**FIELD SERVICE BULLETIN**

FSB Number: LVCCFSB2005-52  
Author: Tony Bryan  
Date: March 21, 2005  
Total No. of Pages: 3  
Subject: GSM Intermittent Alert – Pogo-Pin Contact Force  
Phone Models: GSM V547, V551, V555, E550/V535, V545/V550, V300,  
V303, V400, V505, V500/V525  
Level of Repair: 2

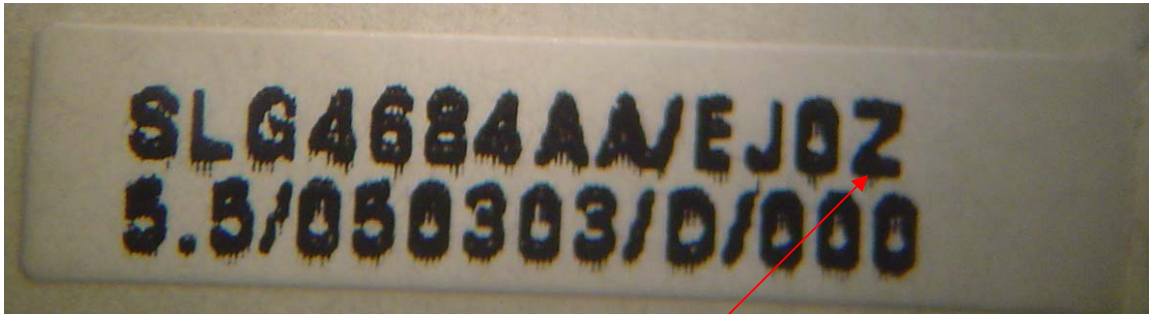
A re-design of the 3988194N01 pogo-pins was completed to increase the specification for contact force at the nominal pin working height by 30g (+/-10g).

New Pogo-Pin Part Number: 3988427Z01

The factory cross-over to the new 3988427Z01 pogo-pin design was started, for the affected products listed above, on 3/14/2005. To assist in identification during the cross-over, the factories will add a marking to the current PCBA Label to indicate which pogo-pin was placed. See image below.

For all the PCBA soldered with new pogo pin 3988427Z01, a letter "Z" must be added on the label at the end of line 1,
